Reference Number	Bulletin 01 – 2019*
Affected Product	Potential failure of motor grader front wheel spindles in mining applications
Risks Identified	Failure to apply the recommendations in this Equipment Safety Bulletin may increase the risk of spindle failure
Release Date	18 January 2019 (Revised 06 November 2019 and 25 August 2020)

**A New Spindle Assembly for the Front Axle Group is Now Used On Certain 24H and 24M Motor Graders {4205}  
(SEPD1533)**

A change has been made to Service Magazine, SEPD1701, 27, November 2013 , "New Spindle for the Front Axle Group Is Now Used On Certain 16H and 16M Motor Graders". Please disregard this Service Magazine article and see the article that follows.

Illustration 1

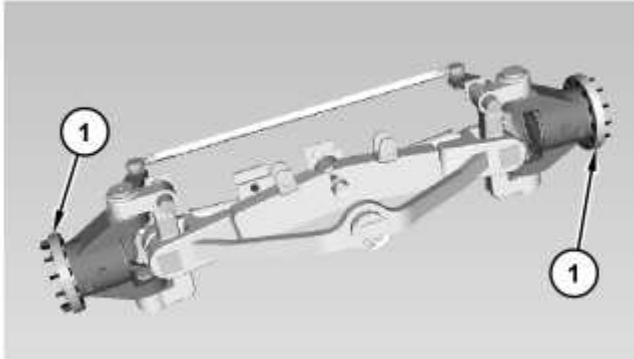
**Description of Change:** A new spindle assembly with improved induction-harden heat process improves the service life of the spindle. A new spindle assembly with improved manufacturing process increases the service life of the front axle group.

The new **383-1185** Spindle As is part of the **8X-8974** Front Axle Gp on the 24H Motor Graders and the **266-5908** Front Axle Gp on the 24M Motor Graders.

The new **383-1185** Spindle As is a direct replacement for the **162-4228** Spindle As for the 24H Motor Graders and the **281-0074** Spindle As for the 24M Motor Graders.

The new **383-1185** Spindle As is adaptable to machines 7KK1-UP and B9K1-653.

The new **383-1185** Spindle As is effective in production with machines B9K654-UP.

Illustration 1

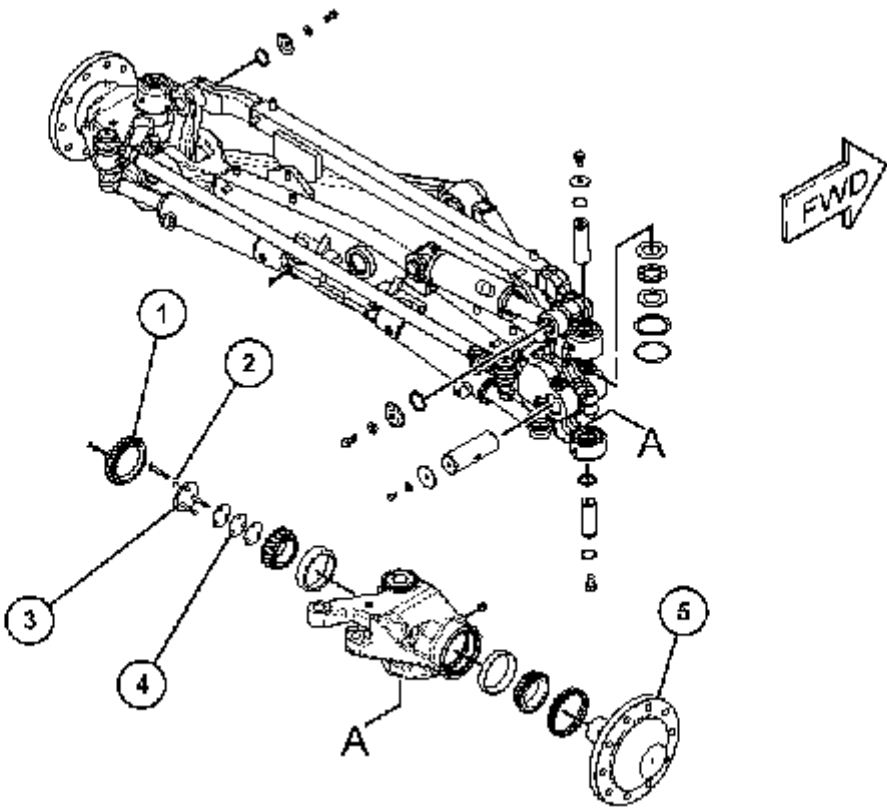
**Description Of Change:** The new spindle with improved design of tapped holes will better withstand high stress and increases the service life of the front axle group.

New **437-8983** Spindle (5) is a direct replacement of **264-1161** Spindle.

New **437-8983** Spindle (5) is a direct replacement of **147-3402** Spindle.

The new **437-8983** Spindle is adaptable to machines **S/N:**6ZJ1-UP, ; **S/N:**ATS1-78001, ; **S/N:**B9H1-866 and ; **S/N:**R9H1-892.

The new **437-8983** Spindle is effective in production with machines **S/N:**ATS78002-UP, ; **S/N:**B9H867-UP and ; **S/N:**R9H893-UP.
